LIBERTY HIGH SCHOOL Administration and Student Commons Modernization

Addendum 02

DECEMBER 21, 2020

Architect's Project No.: 1783.00

SHEET NUMBER ADDENDUM 02 AB4.1

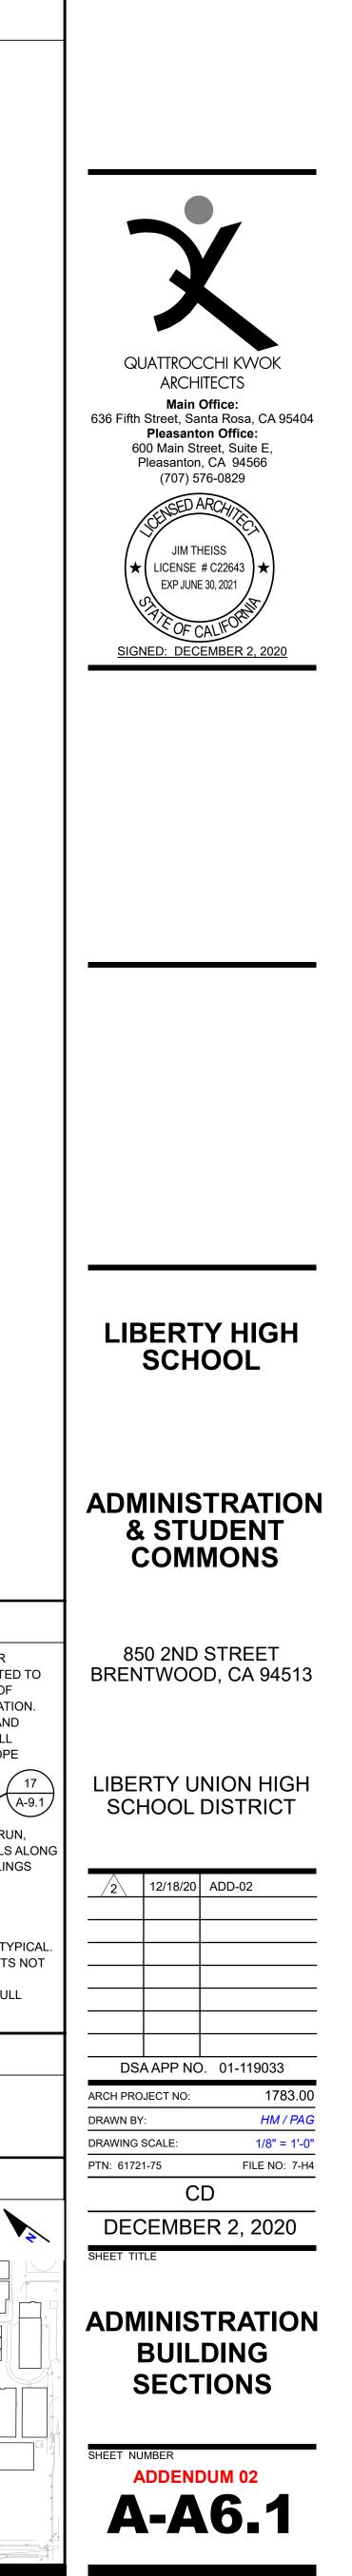
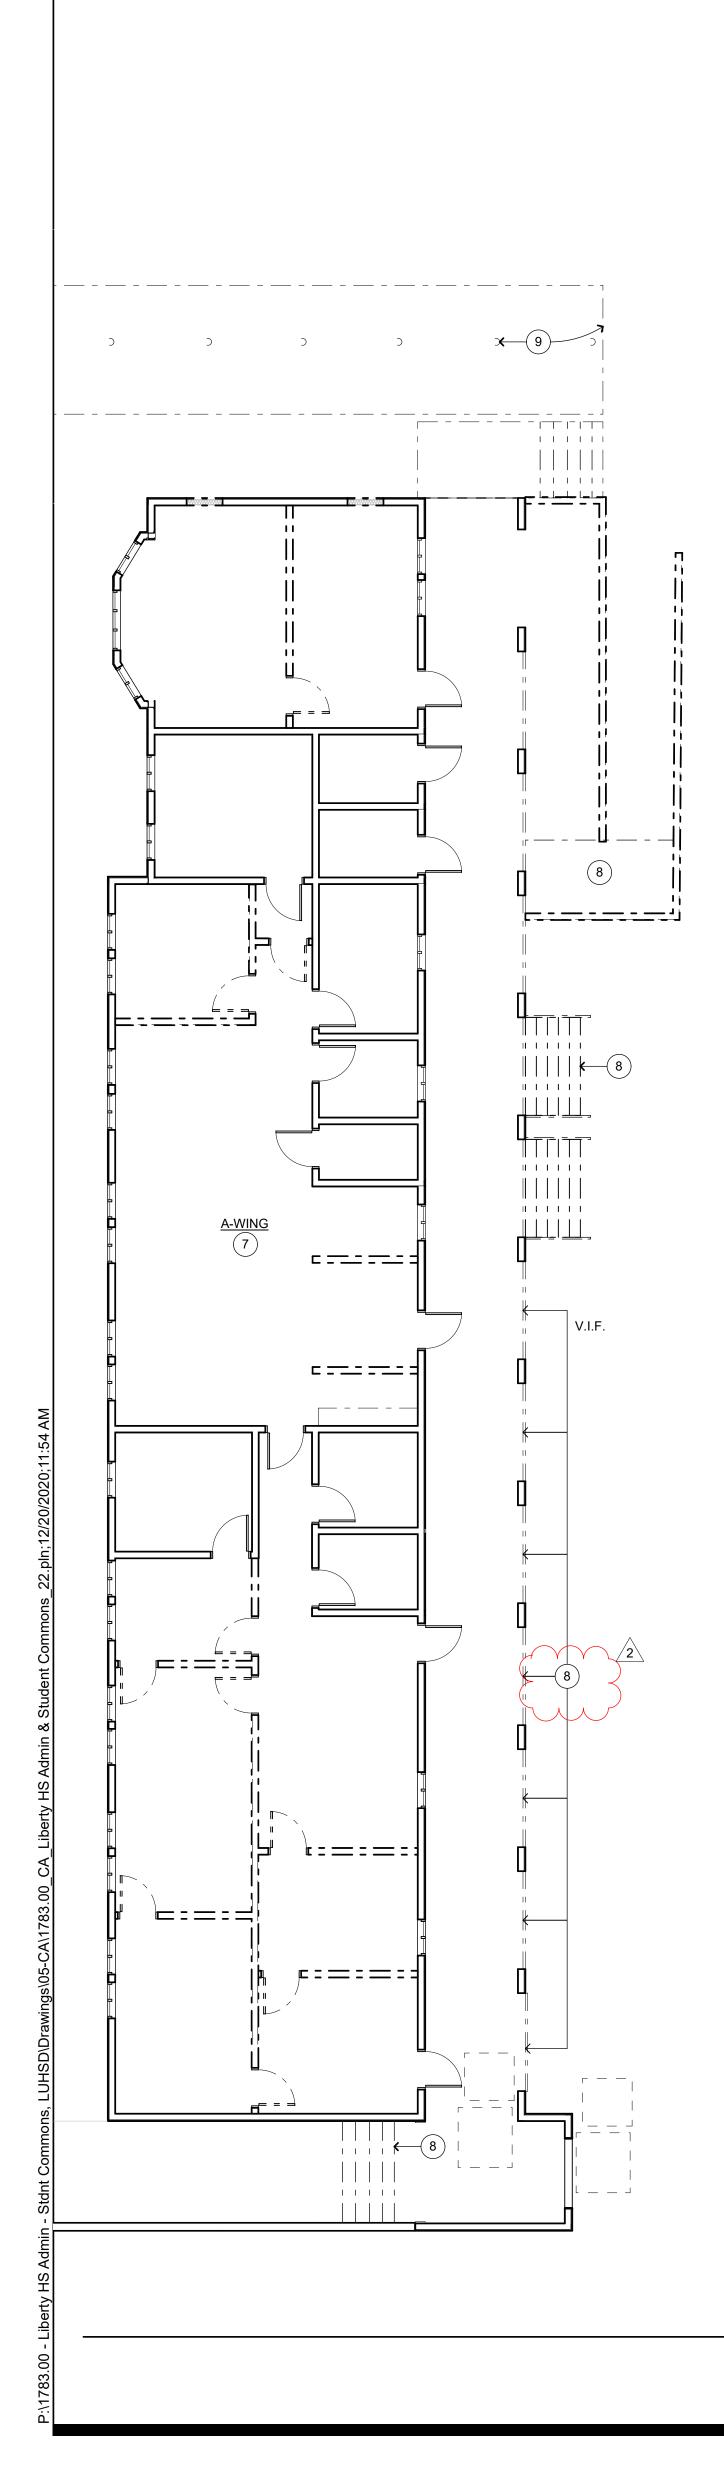
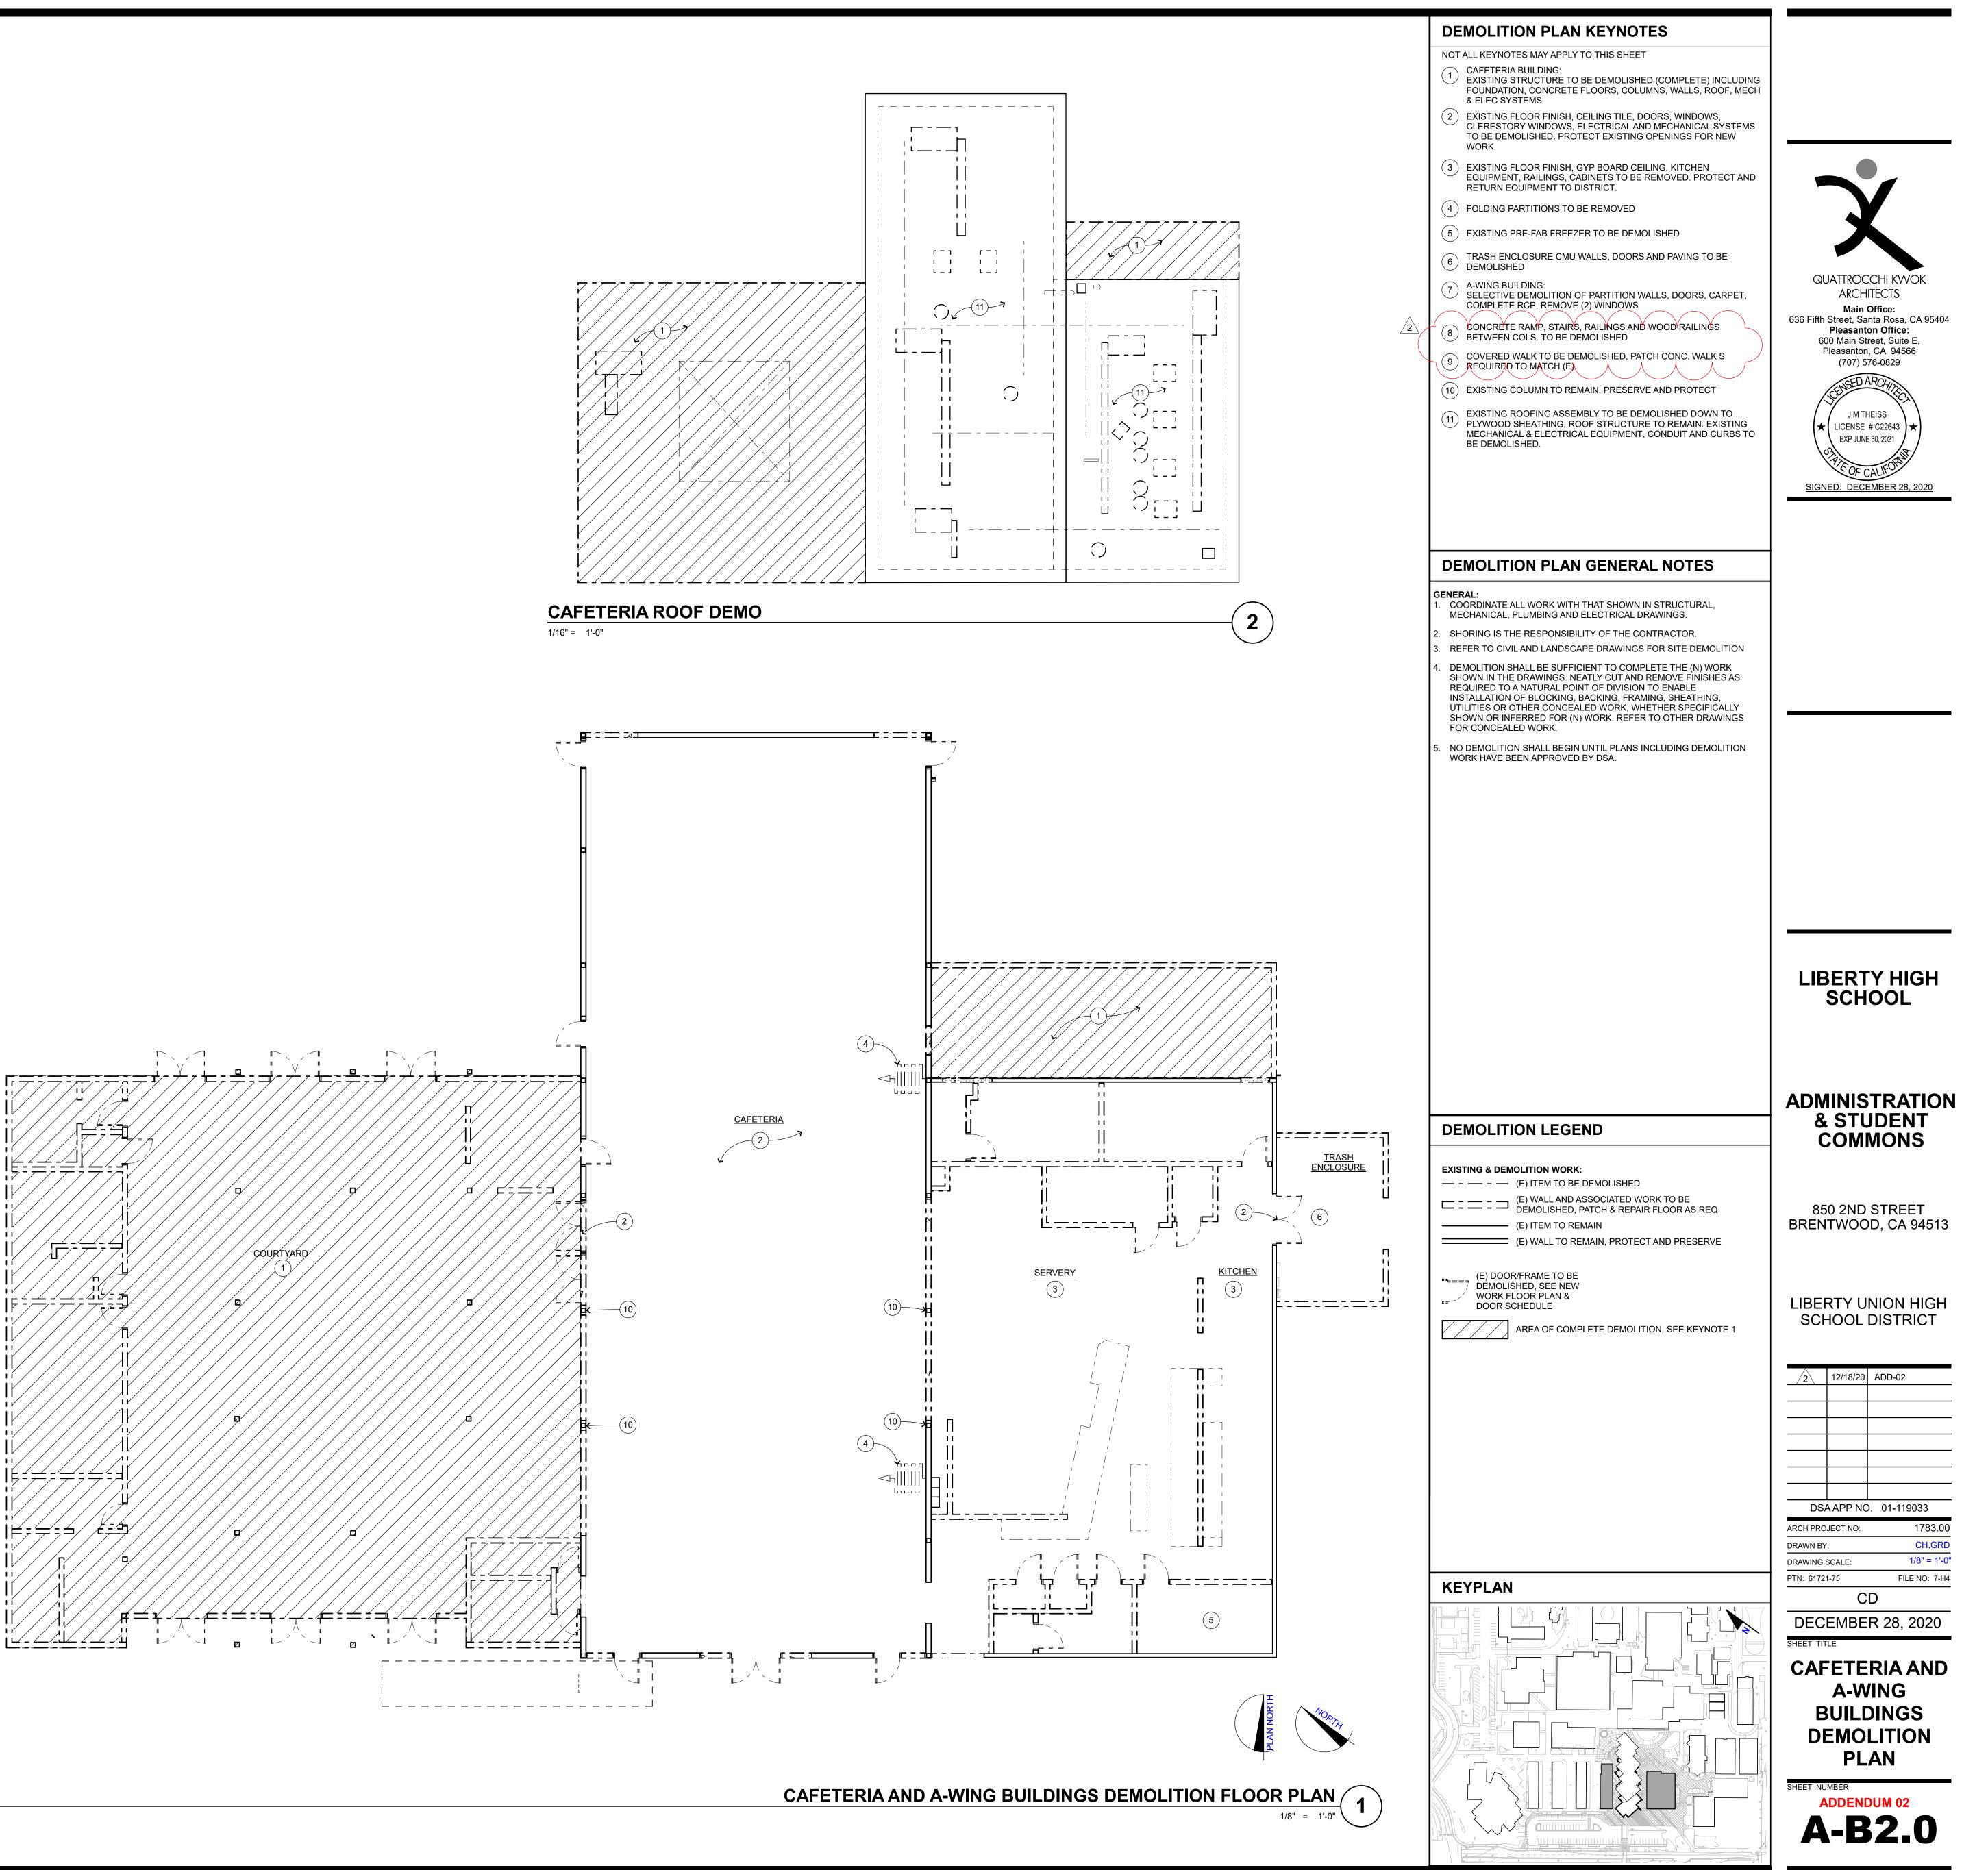
The following drawings dated December 18, 2020 denoted **Addendum 02** supersede and replace previous drawings with the same titles:
